Source: NTT, KDD, NEC and FUJITSU

Title : Connection test results with Test Signal Generator

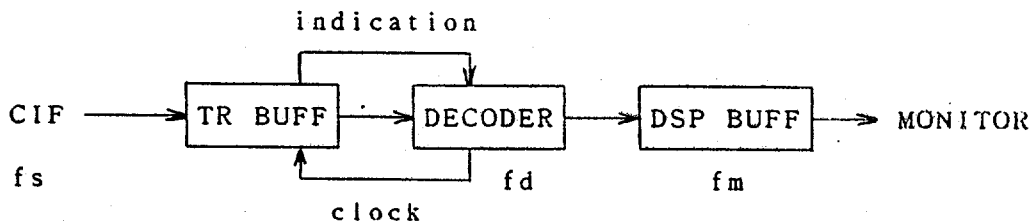
Signal level must turn from 23 to 233 at the first block of the 12th GOB in the 35th frame. Therefore, the difference value for DC coefficient must be  $+1680 = (233-23)*8$ . The corresponding variable length code should be  $V[+80](='0000\ 0001\ 1100\ 0101')$  when QSEL=21. However a variable

length code '0000 0001 0000 1010' is used in the test signal generator. This code represents  $V[+10]$  corresponding to +210 when QSEL=21.

Figure 1  $T_{\text{repeat}} / T_{\text{drop}}$  vs. Decoder operation frame frequency  $f_d$

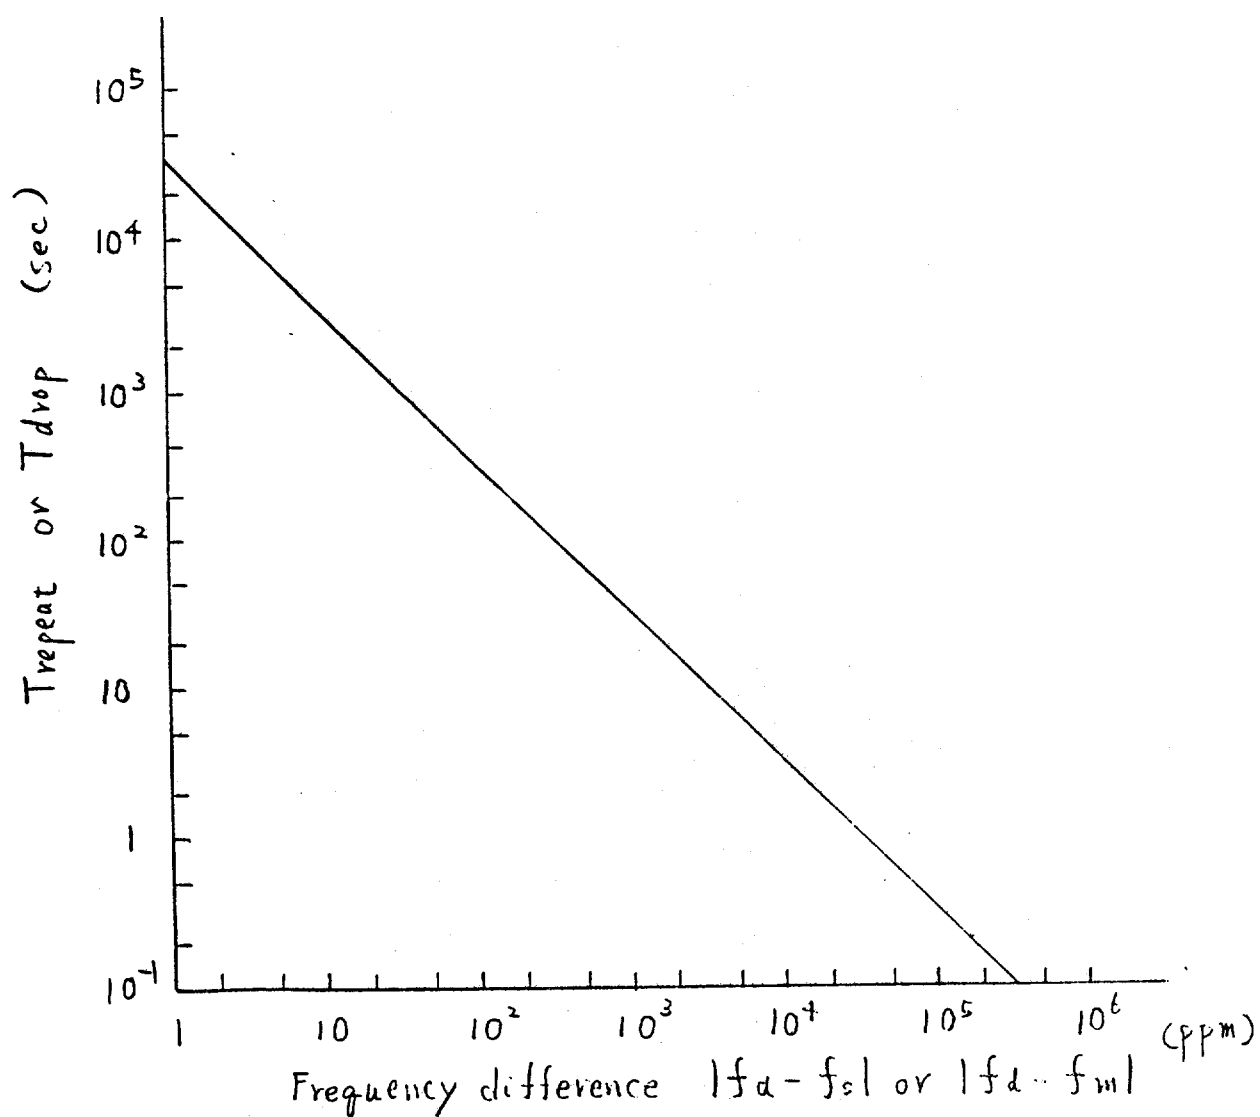
- 3) From 1) and 2), in decoded images for the Sliding Bar sequence, Sliding Bar stops every  $T_{\text{repeat}}$  sec and jumps every  $T_{\text{drop}}$  sec. Figure 1 shows the relation between the frame frequency difference and the interval of frame repeat / frame drop.

For larger value of  $f_d$ , reduction speed is higher. (See Fig.1.)

Suitable Decoder Frame Frequency  $f_d$  depends upon both the interval of frame repeat / frame drop the required time in reducing the decoder line buffer delay (See Doc.#287). The interval of frame repeat / frame drop and the required time are traded off. According to the discussion above, appropriate  $f_d$  is +1,000ppm.
